From: Oliphant, Marc (FTA) <marc.oliphant@dot.gov>
Sent: Wednesday, February 16, 2022 4:36 PM
To: John Hoppie; Kay Shelton
Cc: Lyssy, Gail (FTA); MacFarlane, John <FAA>; terence.plaskon@dot.gov; David Ehrlicher; Nick Stadem (nicholas.stadem@hdrinc.com); Victor Ibewuike; Reza Shirmanesh; Thomas Lebeau; Darwin Desen; Tracey Lober, PE; mantych@burns-group.com; echitsinde@dfwairport.com; Koski, Donald (FTA); Bartels, David (FTA); Wallace, Laura (FTA)
Subject: [External] RE: Silver Line Memo to File Phase B

INTEROFFICE MEMORANDUM

SUBJECT: DART Cotton Belt Corridor Design-Build Changes: Memo to File Phase B

Dallas Area Rapid Transit
Cotton Belt (Silver Line)
Environmental Documentation
Letter to File Phase B

B1. Elimination of DFW Pocket Tracks
Exhibits

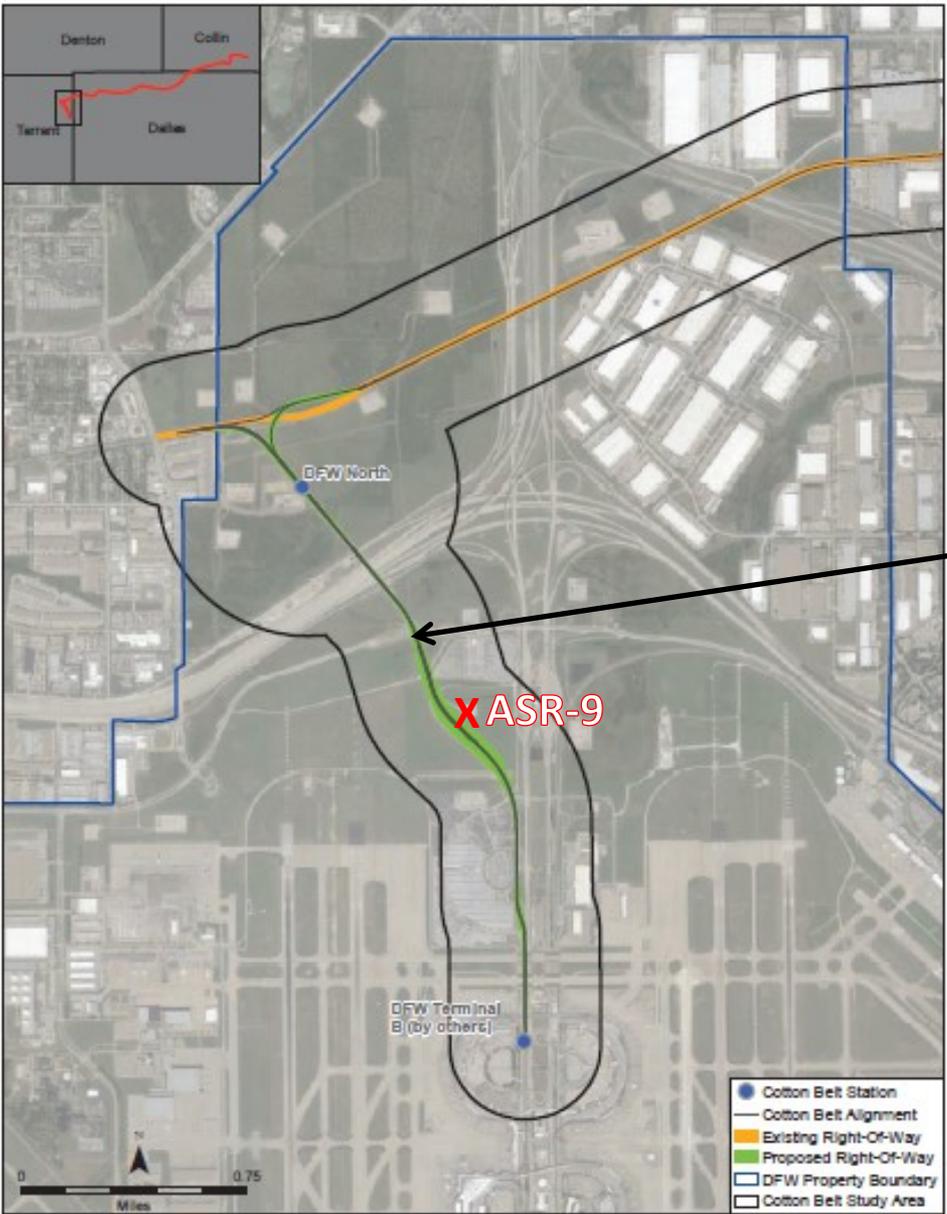
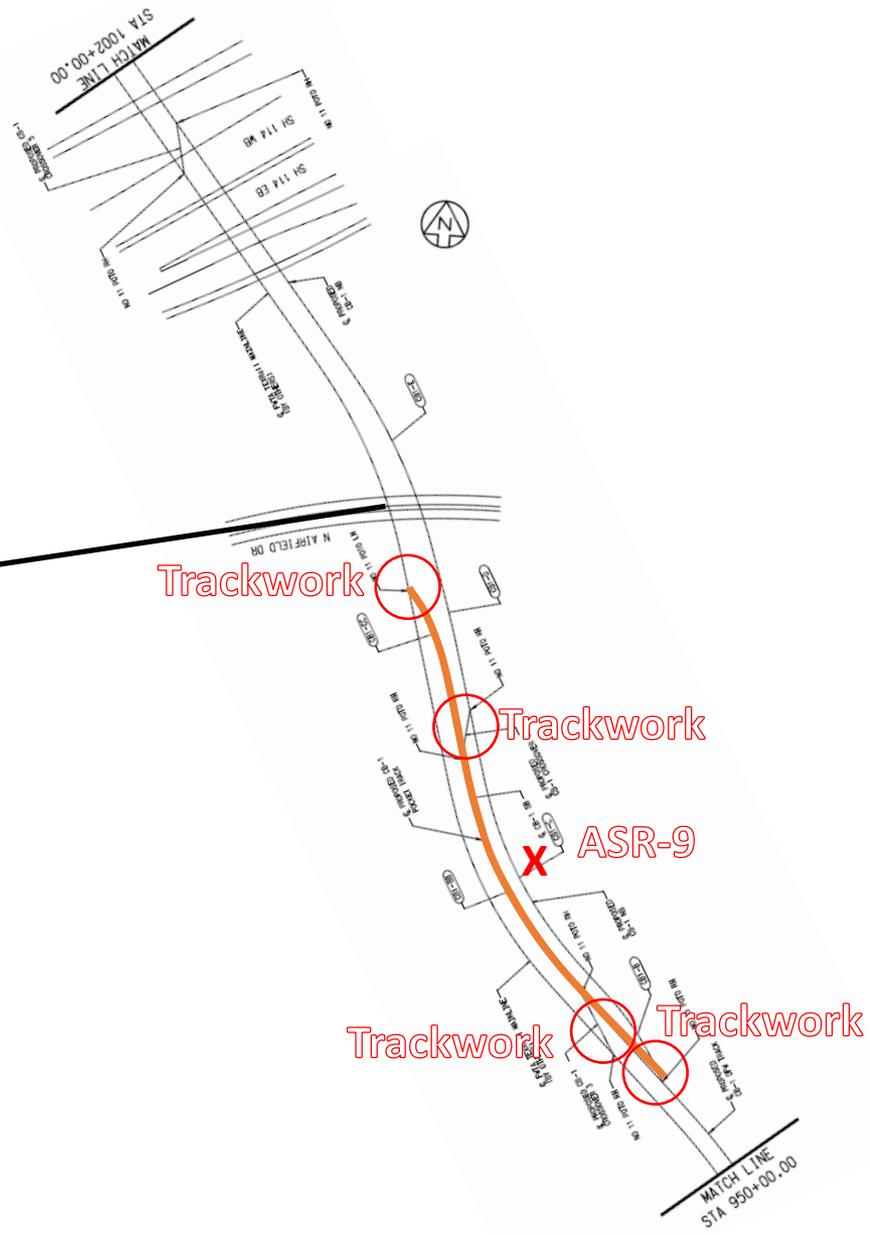
As described in **Sections 2.3.1, 2.3.5 and 6.2** of the **FEIS**, Trinity Metro (TEXRail) has constructed a single-track rail alignment extending from DFW Terminal B to the DFW North Station. As part of the Cotton Belt Project DART would construct a second track and a siding in this corridor. Hereafter, this siding is referred as the DFW Pocket Track. The planned location of the DFW Pocket Track is shown in **Exhibit 1** in **Attachment 2**.

Advancing the design of the Silver Line Project revealed that there are utilities that cross the rail corridor in the vicinity of the DFW Pocket Track, which were installed during the Trinity Metro TEXRail construction. This includes an Oncor electric line that serves the ASR-9 Radar Tower. (As discussed in **Section 6.4.1.7** of the **FEIS**, FAA ASR-9 tower is adjacent to the alignment at DFW Airport). Constructing the pocket track would require extensive excavation and installation of retaining walls that would conflict with these utilities. As identified in Mitigation Measure **COR-31** of the **FEIS/ROD**, DART will attempt to minimize and mitigate disruption of utilities during construction. Additionally, DFW Airport staff have expressed a desire to avoid the utility impacts at the airport.

The elimination of the Pocket Track has several benefits:

- Eliminates major utility relocations
- Eliminates construction electrical outages
- Reduces excavation
- Reduces DFW property acquisition (Mass Transit Easement)
- Eliminates construction of approximately 1,900 feet of track
- Eliminates special trackwork connecting the pocket track to the TEXRail and Silver Line Tracks at four locations
- Reduces potential construction disruption of TEXRail Service
- Reduces construction duration on DFW property
- Reduces construction, material, and right-of-way costs

Additionally, the elimination of the DFW Pocket Track will also reduce the potential for a vibration impact to ASR-9. Besides reducing the number of tracks proximate to the radar facility, the special trackwork connecting the two rail lines to the pocket track would also be eliminated. As discussed in the FTA *Transit Noise and Vibration Impact Assessment Manual* (September 2018), wheel impacts at special trackwork, such as frogs at crossovers, create much higher vibration forces than typical track conditions. Because of the higher vibration levels at special trackwork, crossovers are the principal areas of vibration impact on new systems.

The track configuration at the DFW North Station eliminates the need for the DFW Pocket Track. The elimination this track reduces property acquisition, reduces utility impacts and reduces the potential for vibration impacts to FAA Tower ASR-9. This design change does not appear to add any new impacts and has been requested by DFW Airport. No additional environmental study is warranted.

Figure 2-4
DFW North Station

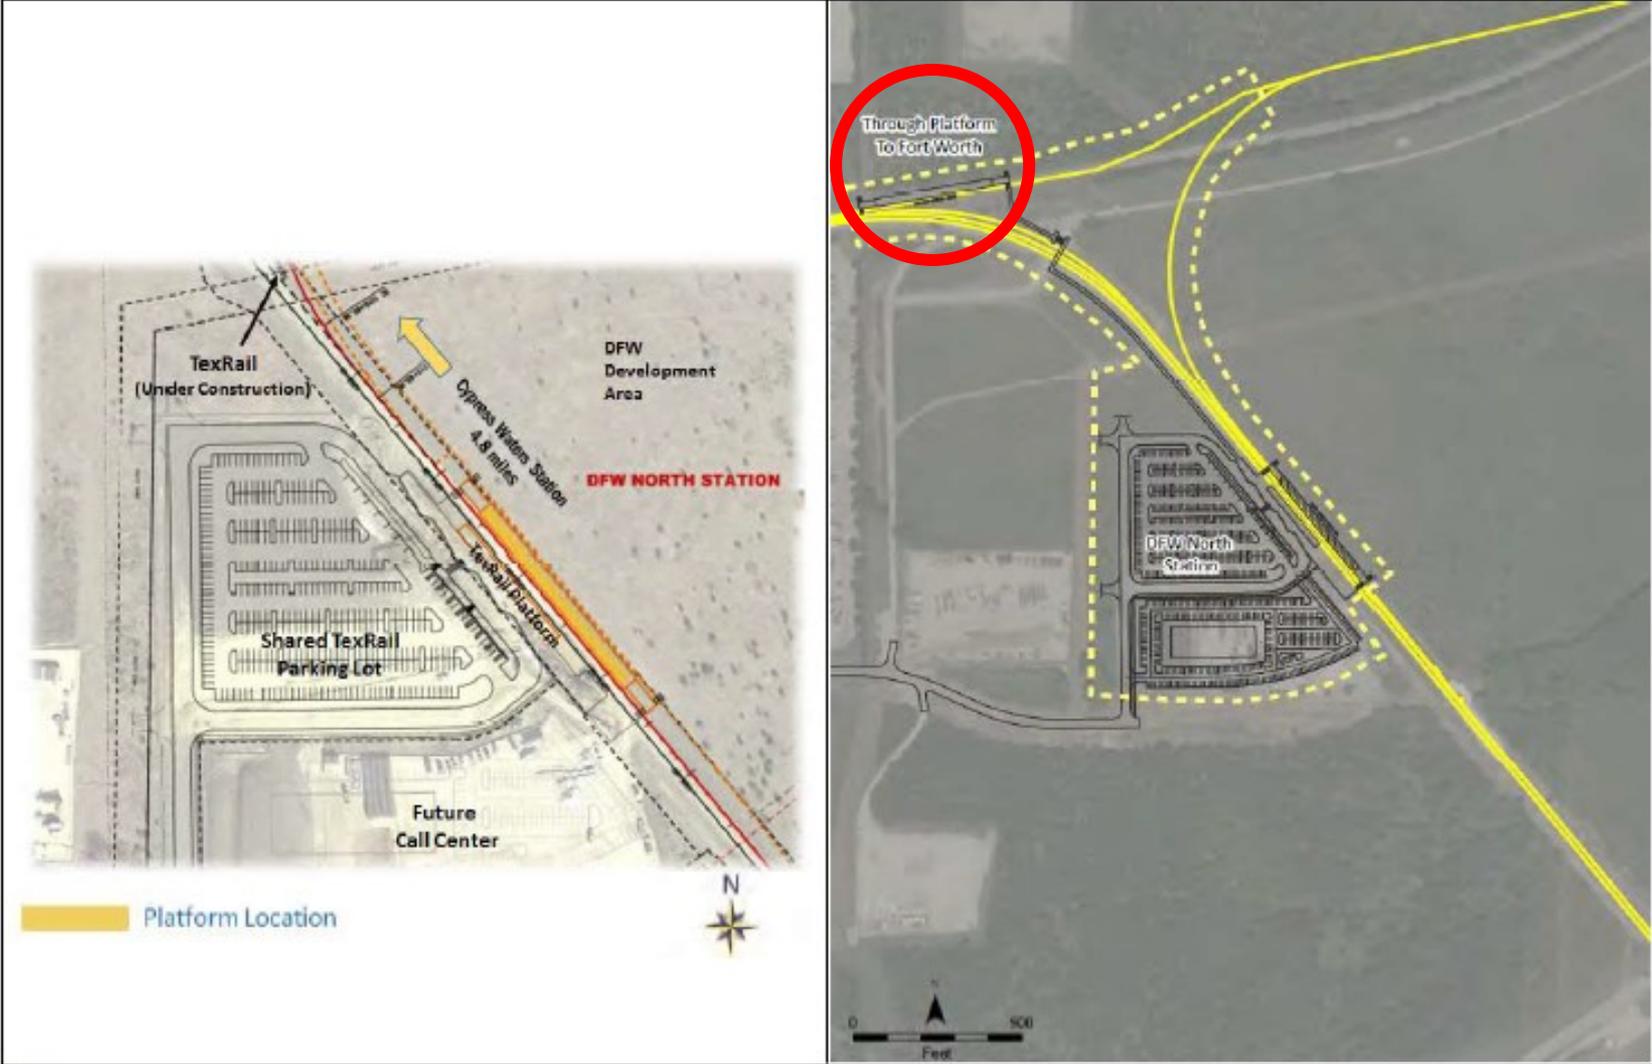
As described in **Section 2.3.1** of the **FEIS**, the DFW North Station complex will also include a future pass-through platform that would allow for east-west “through” service to Fort Worth without entering the DFW central terminal area. (see **Exhibit 1 in Attachment 3**). An Architectural Site Plan of the for the DFW North Through Platform from **FEIS Appendix A.4** is shown in **Exhibit 2 in Attachment 3**.

Additional double tracking of the TEXRail Corridor, by Trinity Metro, would be required to operate the “through” service. As a cost saving measure, DART has opted to defer construction of the through platform until this additional TEXRail infrastructure is in place and cross-corridor service is possible.

The deferral of the DFW North “Through” Platform does not appear to change any of the findings for the FEIS /ROD. No additional environmental study is warranted.

Oncor Tower Locations in Relation to Cypress Waters Station

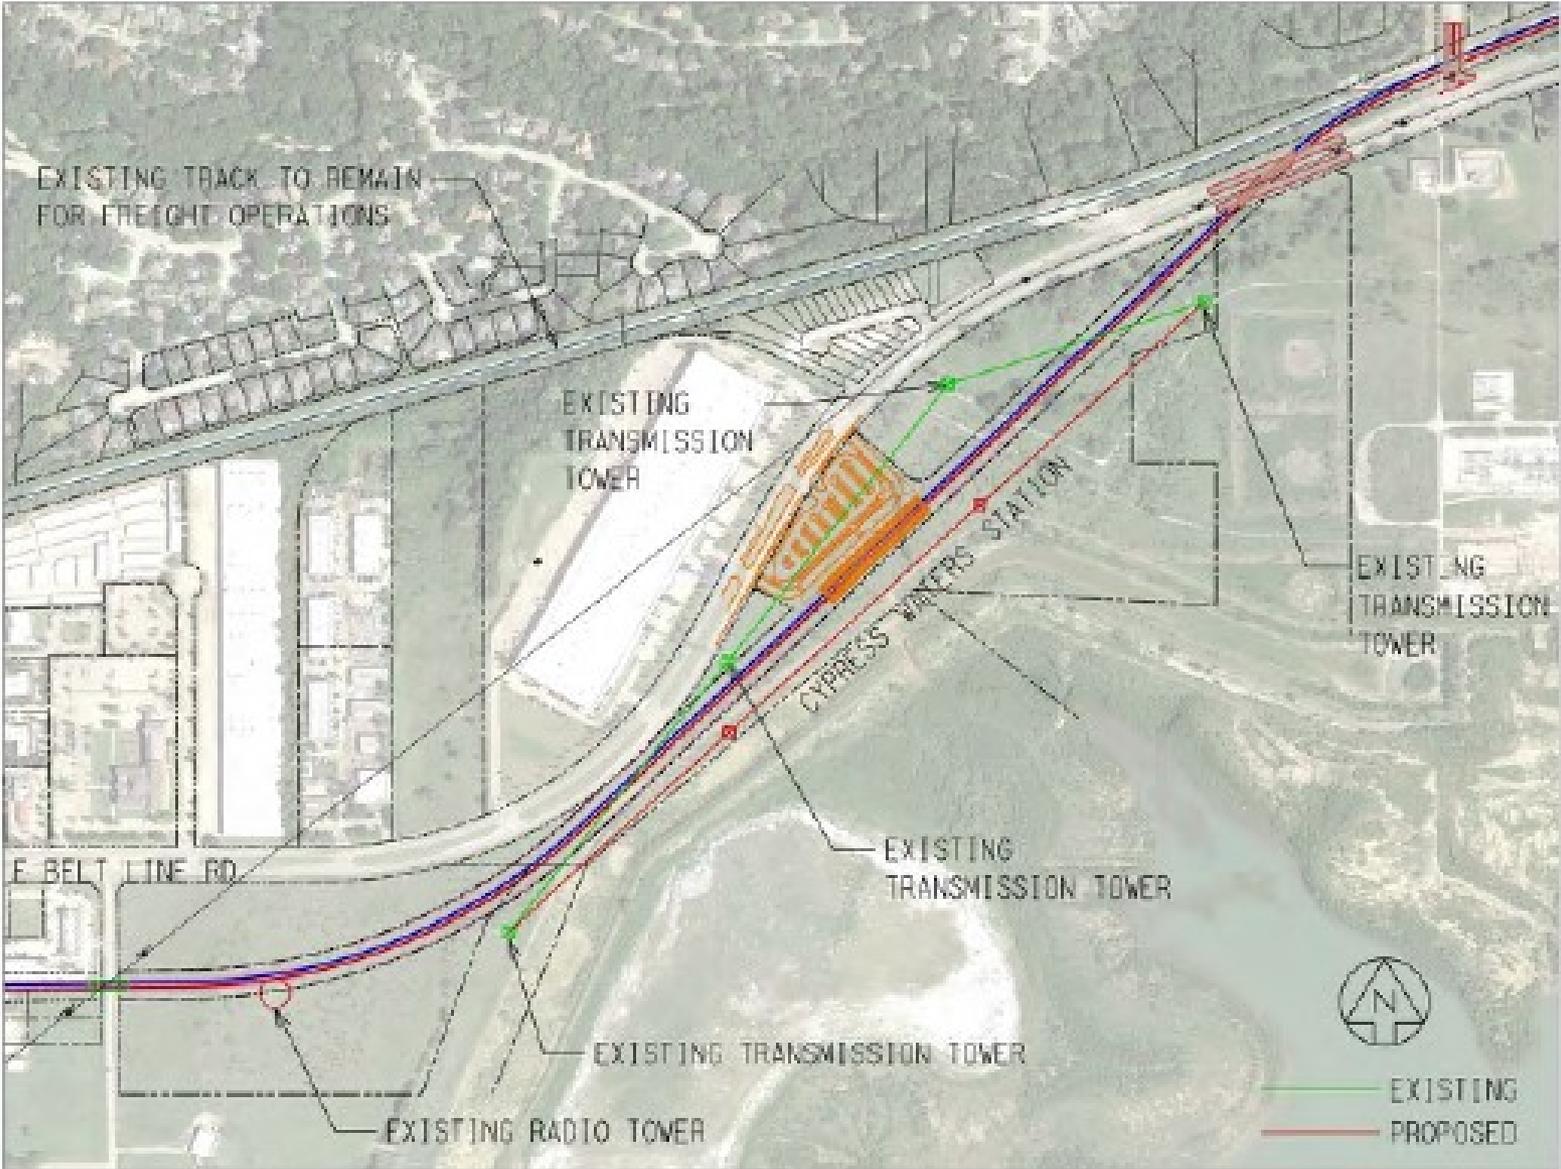
As discussed in **Section 4.21.3** of the **FEIS**, a high-voltage electric transmission line bisects the parking lot at the Cypress Waters Station area and crosses the rail line on a skew. Oncor policy regulates development under the transmission line. **Exhibit 1** in **Attachment 4** illustrates the transmission line in relation to the station.

As identified in Mitigation Measure **CB1-4** of the **FEIS/ROD**, DART would relocate one or two of the transmission towers in Cypress Waters area to reconfigure the transmission lines crossing of the rail and station. Mitigation Measure **CB1-2** recommended additional archeological testing is for the Oncor transmission tower relocations. Subject to further design, the tower relocations would have likely required additional environmental analysis.

Ongoing coordination with Oncor eliminated the need to relocate the towers. DART slightly adjusted the alignment to pull the rail away from the base of a tower without requiring any relocation. Oncor sag analysis of the existing wires they found that the wires were sagging below the 34' min clearance required in the Cypress Waters station area. To eliminate the sag, DART will add two new poles to raise and support the transmission lines. The new poles will be significantly smaller than the existing towers and will be located within the station parking lot islands (See **Exhibit 2** in **Attachment 4**). The alignment shift and additional poles are within the environmentally cleared area and does not alter the property acquisition needs.

The elimination of the Oncor Tower Relocations resulted in significant cost savings and eliminated the potential for additional environmental impacts and mitigations associated with the relocations. The design change which includes adding two utility poles within the station footprint does not add any new impacts. No additional environmental study is warranted.
